2 Type of change

0909 Multiple IEC Appliance Outlets F					
Release date:	Released by:				
24.5.2011	SHO				1 von 2

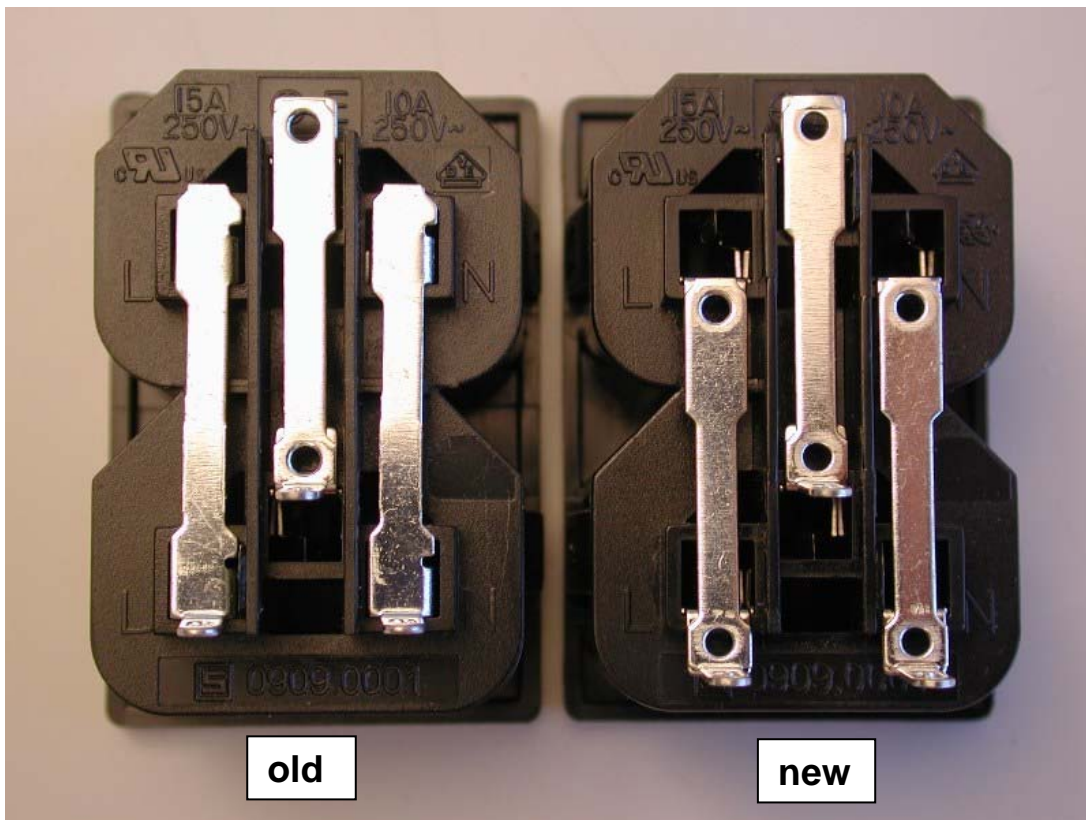
- L and E bars newly riveted to contacts, now are all 3 bars (L/N/E) riveted.
- Position of solder terminals of L&N are moved approx 5mm towards the border of the connector.

The old version had only the earth bar riveted to the outlet contacts - L/N bars and contacts were made of one piece. The new version has L/N/E riveted. (The holes are the riveting joints)

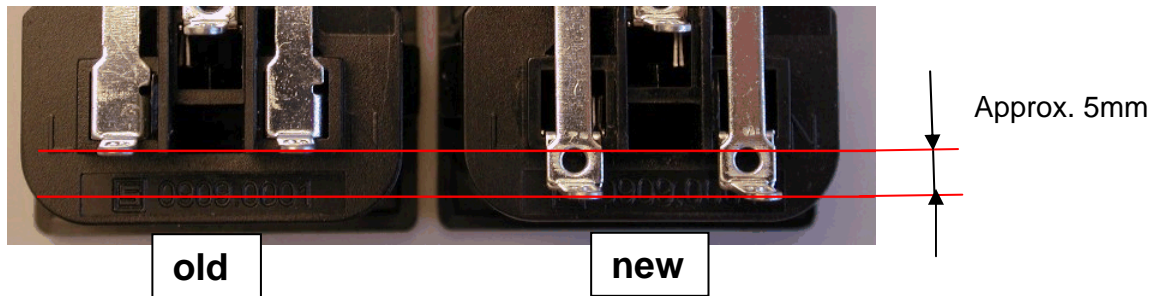
Position of solder terminals of L&N are moved approx 5mm towards the border of the connector.
